SUPPLEMENTAL ENVIRONMENTAL IMPACT STATEMENT for the Alpine Satellite Development Plan for the Proposed Greater Mooses Tooth One Development Project

Volume 3: Chapter 8 Public Comments and BLM Responses

October 2014

Figure 3.3-7
2012 Avian Survey in Relation to Project Study Area

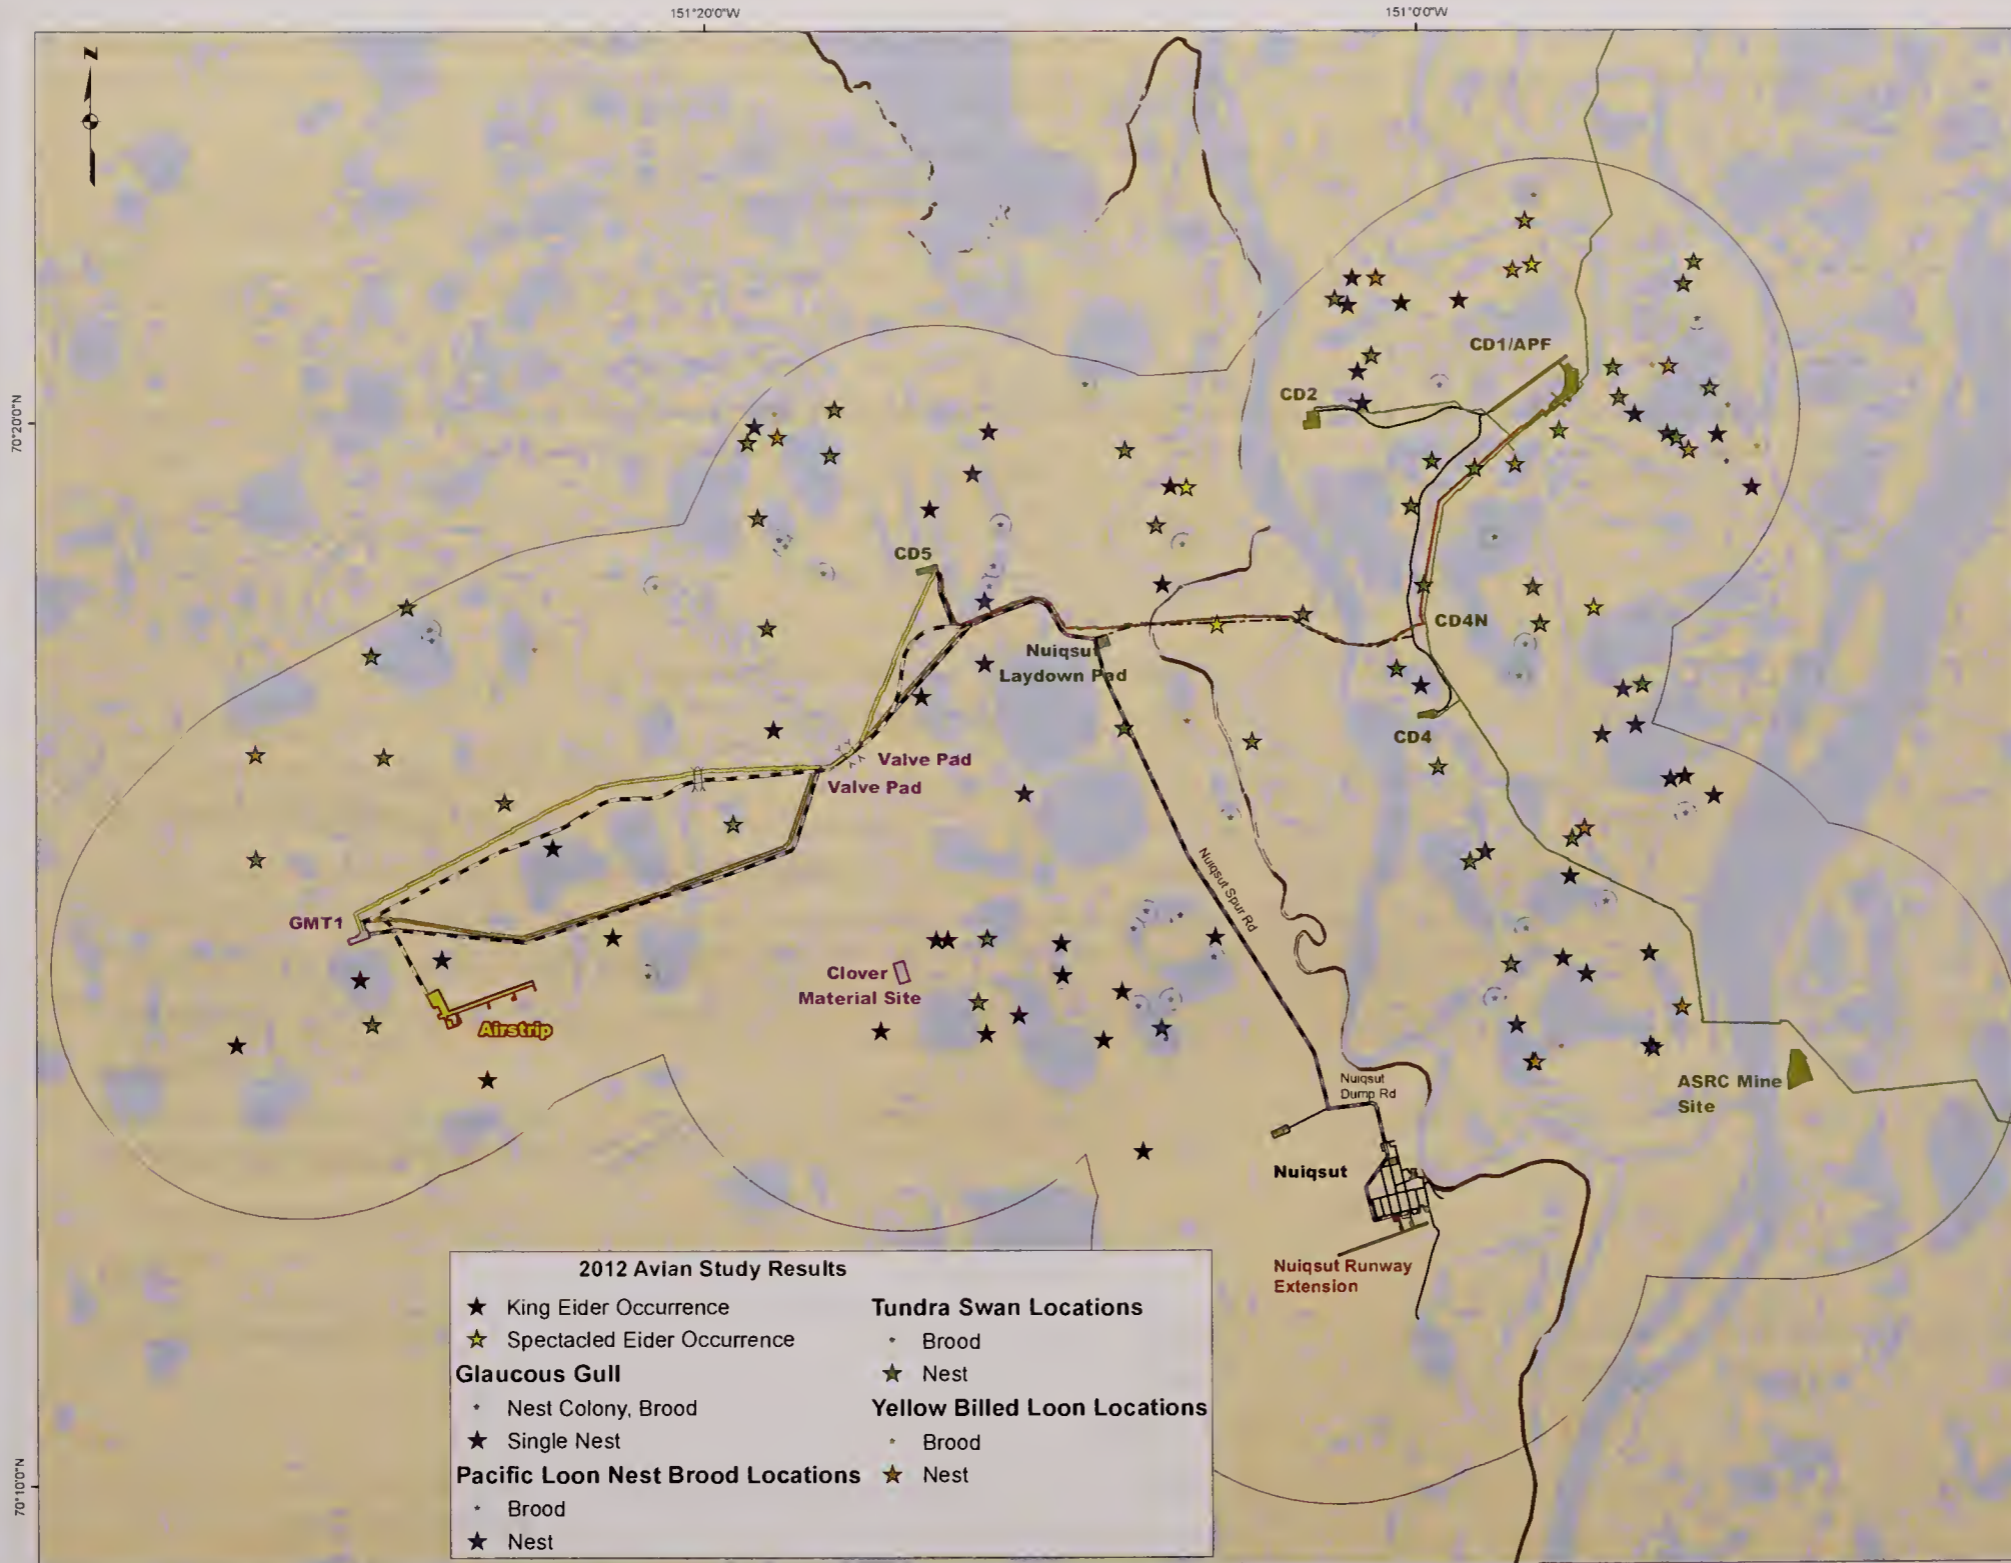
| USACE | | Birds 3.3.3 | 476 | Figure 3.3-7 | | [T06-058] The color of the stars for king eider occurrence, glaucous gull nest, and pacific loon nest are very similar and hard to differentiate on the map. Recommend changing color or shapes. |

| Name | Section | Unnumbered subsection | Page | Paragraph | Comment |
|------|---------------|---|------|-----------|---|
| CPAI | Figure 3.3-7 | 2012 Avian Survey in Relation to Project Study Area | 476 | - | [T18-276] Identify that the data in this figure are restricted to aerial surveys, otherwise include ground-based survey data, such as nest locations of eider and Red-throated Loons. Change the title to "2012 Avian Survey in the Project Study Area". (Remove "in Relation to"). Title is misleading. |
| CPAI | Figure 3.3-7 | 2012 Avian Survey in Relation to Project Study Area | 476 | - | [T18-277] Only 2012 data is displayed, when other years are available. Need to explain why in text; 2012 is probably a good representation of the distribution of these species, but if it is intended to show an "example" distribution, should state so explicitly. |

The reference to Figure 3.3-7 has been removed from Section 3.3.5. The nature of a supplemental document is to communicate new data not presented previously. This is what the Final SEIS text does; however, it also provides data from previous years within the text for comparison. BLM does not agree that an explanation should be included that the primary focus of a supplemental EIS is to communicate new data. Explanation of this concept is adequately provided in Section 1.4: "This SEIS has been developed to supplement the 2004 ASDP EIS, focusing on the changes that have occurred in the interim to the project design, the affected environment, and the regulatory framework in order to provide sufficient information for BLM and other federal agencies to fulfill their NEPA responsibilities."

Figure 2: Species of concern within project area (Source: Audubon Alaska)

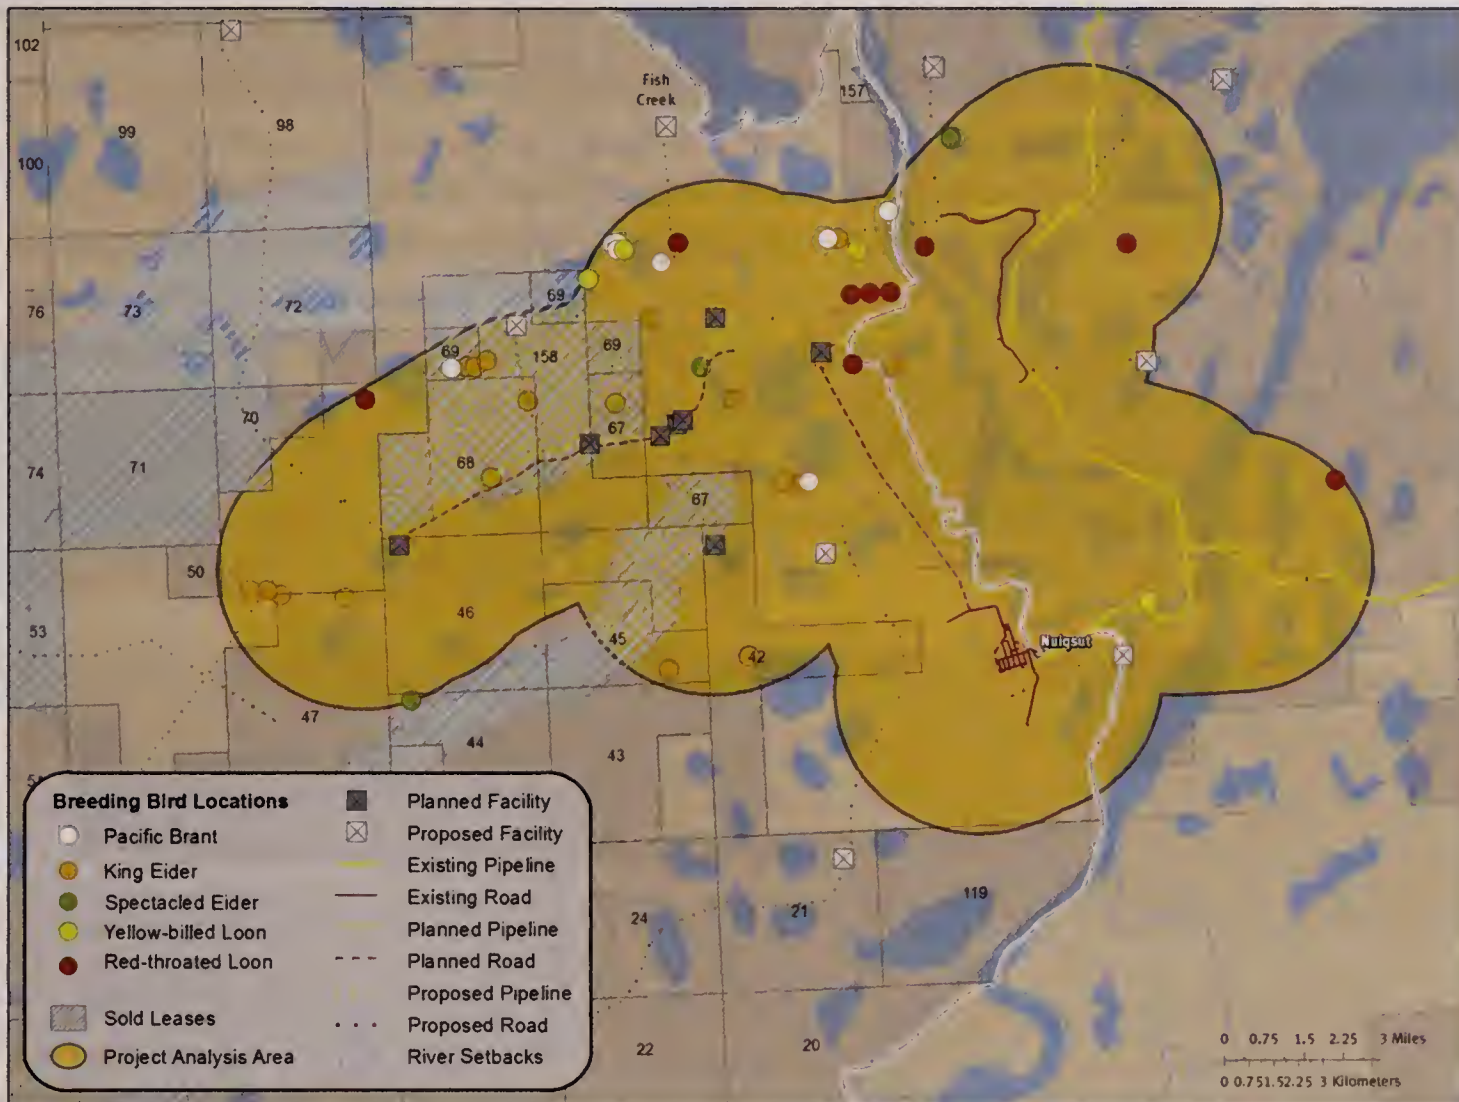
As shown in Figure 2, there are 80 locations within the project analysis area for five species of concern, mapped based on the Alaska WatchList of vulnerable and declining populations. The species and number of locations are: Spectacled Eider (16), Yellow-billed Loon (4), King Eider (30), Pacific Brant (18), and Red-throated Loon (12). Within the larger cumulative effects area, 623 locations for the five WatchList species are: Spectacled Eider (47), Yellow-billed Loon (21), King Eider (349), Pacific Brant (142), and Red-throated Loon (64). It is not known from these data whether the breeding sites were used multiple times over the ten-year period. For planning purposes, the location of used habitat in proximity to infrastructure should be considered during project implementation, and direct and indirect impacts should be avoided.

Figure 1. **[16-012]** Subsistence caribou harvest areas for Nuiqsut from Braem et al. 2011 that could be used to quantify changes in simulated caribou abundance and distribution.

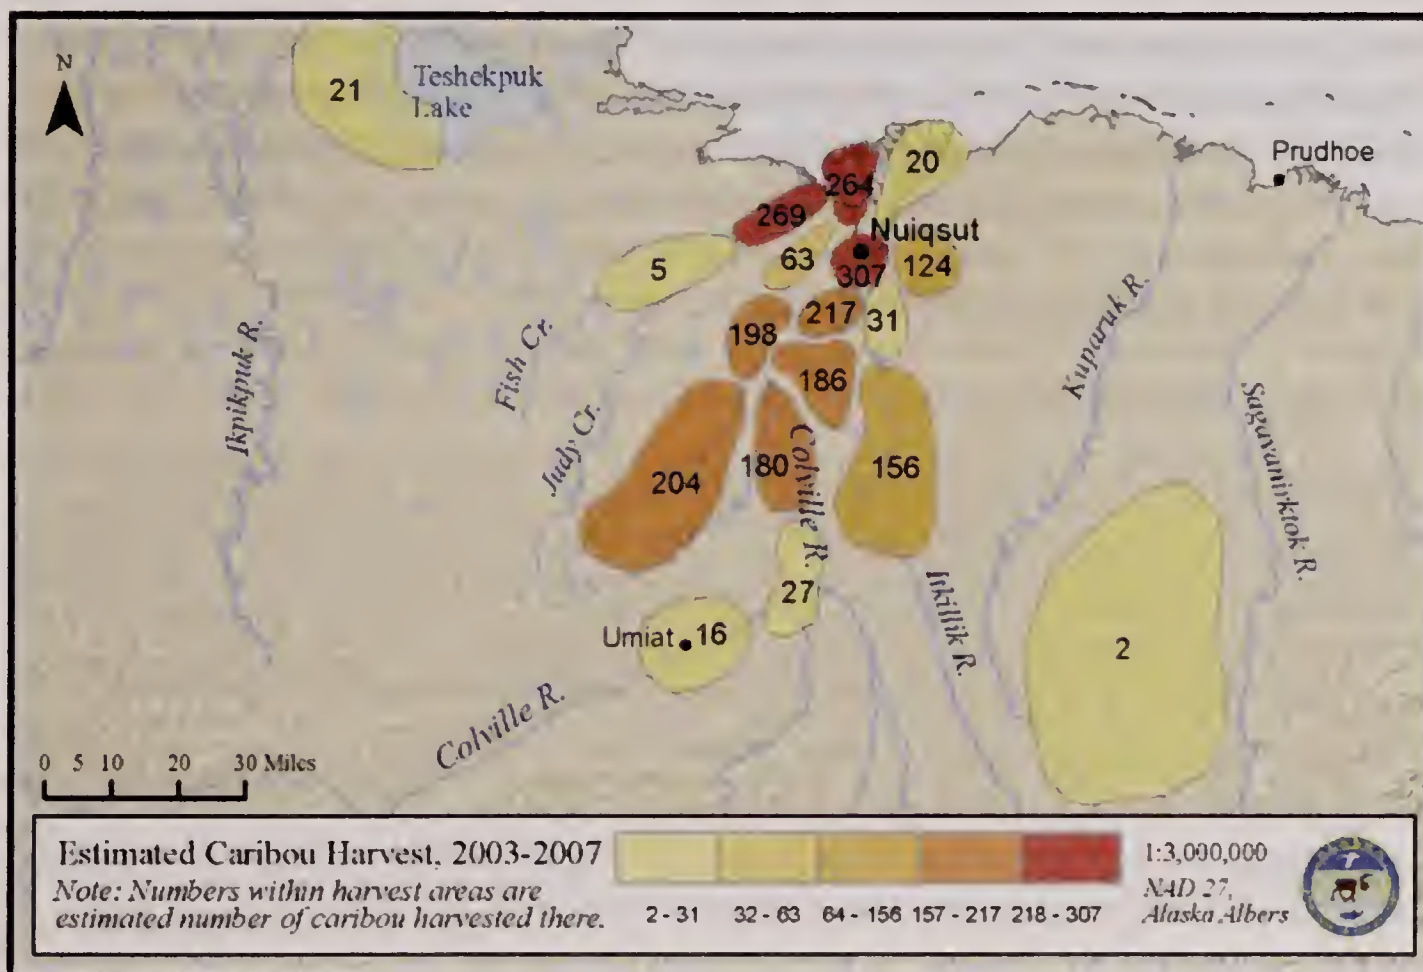
[16-011] To determine how hunter access to caribou might be altered, an attempt should be made to understand how changes in caribou use of the area due to the road changes the distribution of caribou in subsistence hunting areas, such as those depicted by in studies (Braund et al. 2013; Braem et al. 2011; Figure 1). Comparison of no development (Alternative E) vs. development scenarios (Alternatives A-D and any modifications for FSEIS) will allow for a comparison of how each alternative might affect hunter cost and probability for success.

Figure: Caribou Harvest Locations Years 1-4 in Alternative A

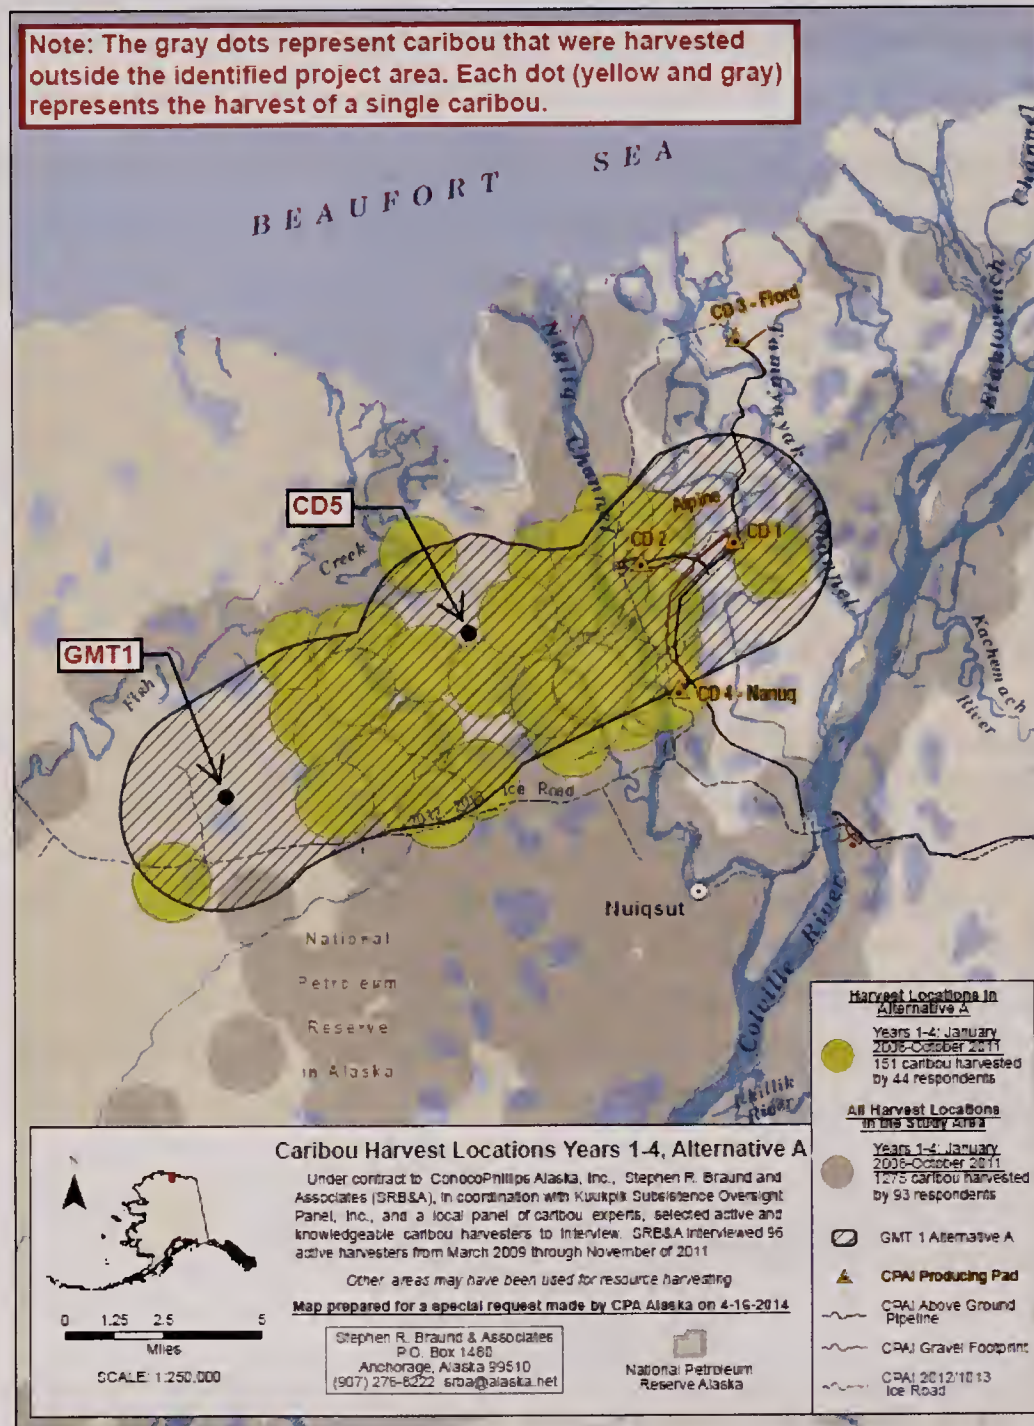
[18-067] This data indicates that 26% of caribou harvested from Nuiqsut are harvested in the project study area. Conversely, 74% percent of the caribou are harvested elsewhere. Looking at ConocoPhillips’ proposed project, only 12% of caribou are harvested in the area associated with Alternative A. No project alternative has a lesser impact on harvest areas. Of that 12 percent, the vast majority of caribou harvested are taken along the rivers that are in the project study area only because they would be crossed at one location by a road and pipeline, which would not exclude the continued harvesting of caribou on those areas. [See Figure below “Caribou Harvest Locations Years 1-4 Alternative A.”]

Figure 1: Proposed GMT1 Pipeline Design Height

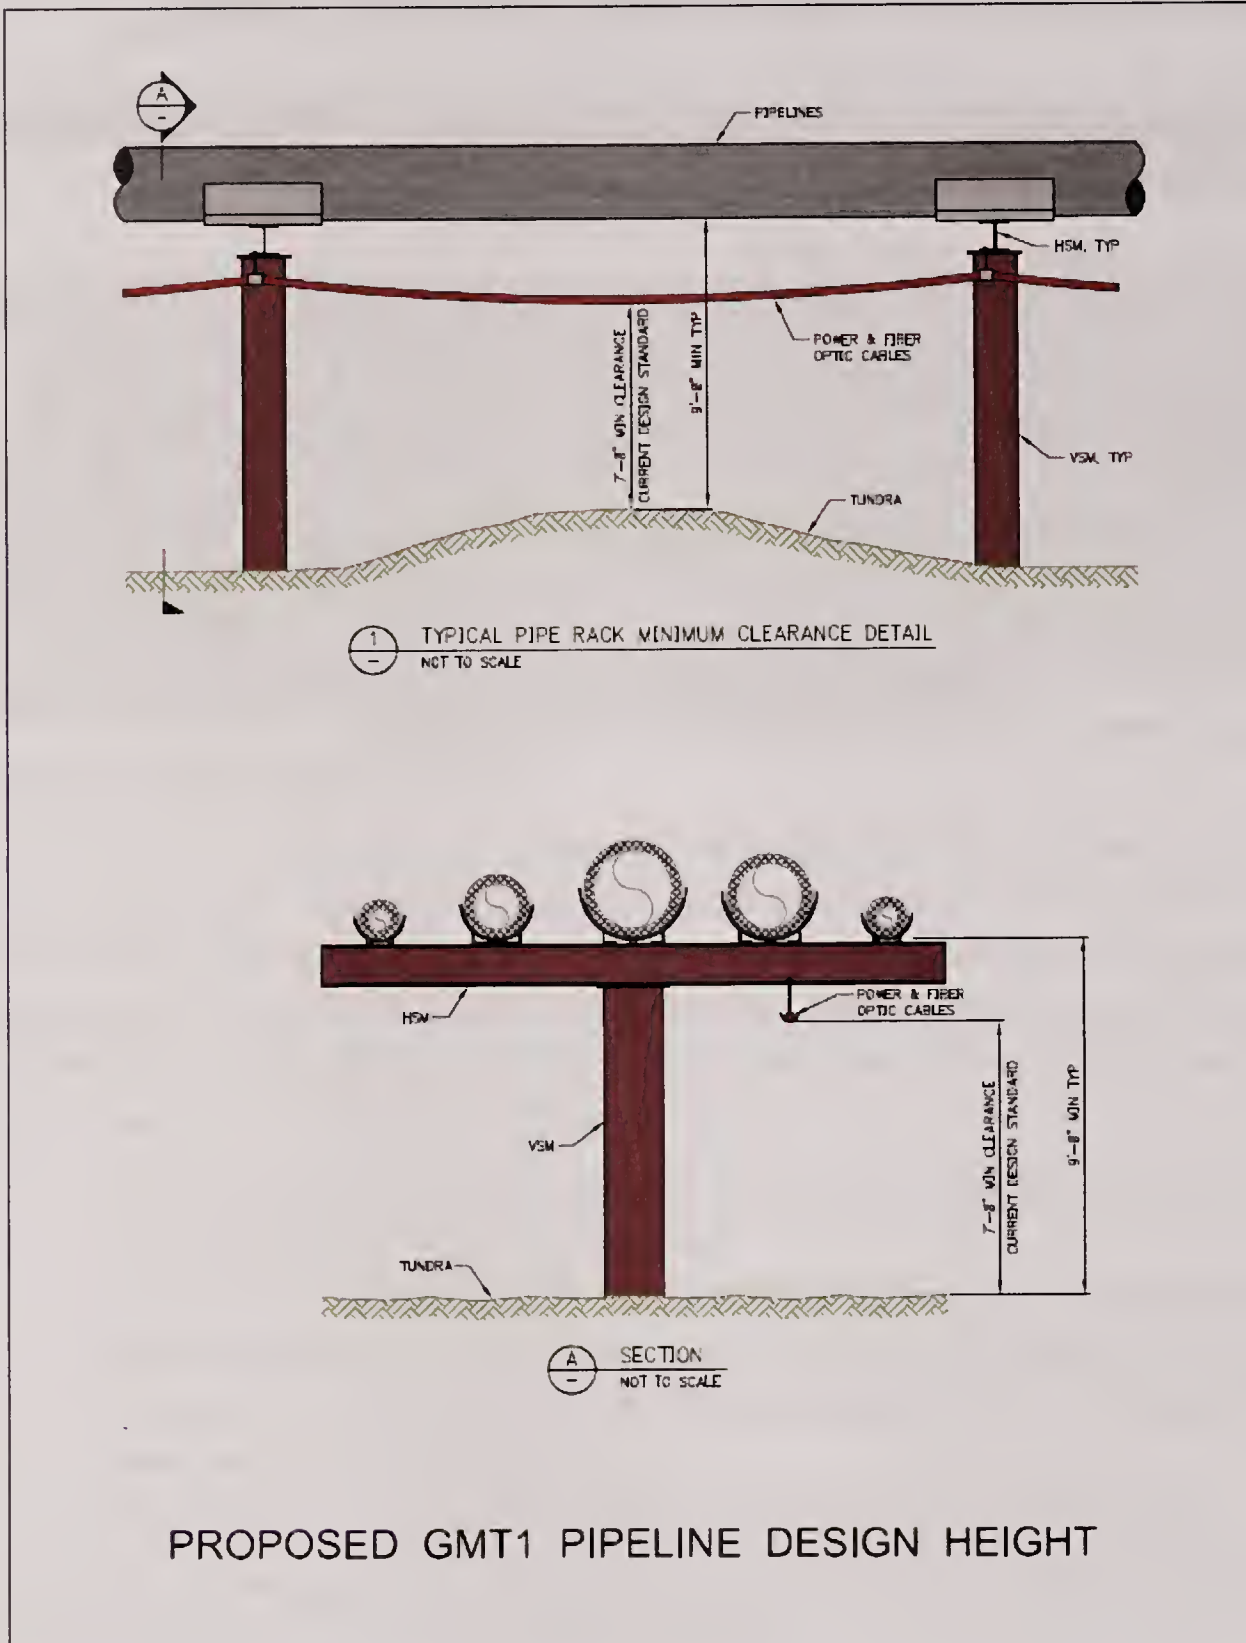
[18-128] Pipelines and roads are designed to allow free movement of caribou and the safe, unimpeded passage of the public while participating in subsistence activities. Above-ground pipelines are elevated a minimum of 7 ft as measured from the ground to the messenger cable installed on the pipeline VSMs. In most instances, this relates to a minimum distance of 9 ft from the ground to the bottom the pipeline (Figure 1). Depending on the terrain and the hydraulic design, this actual height can be much greater. For example, the height from the ground to the bottom of the pipeline for the CD5 pipeline ranges from 10 – 24 feet (at Lake M9525) (Figure 2). A minimum distance of 500 ft between pipelines and roads will be maintained, where feasible, as studies have shown that this facilitates caribou movement.
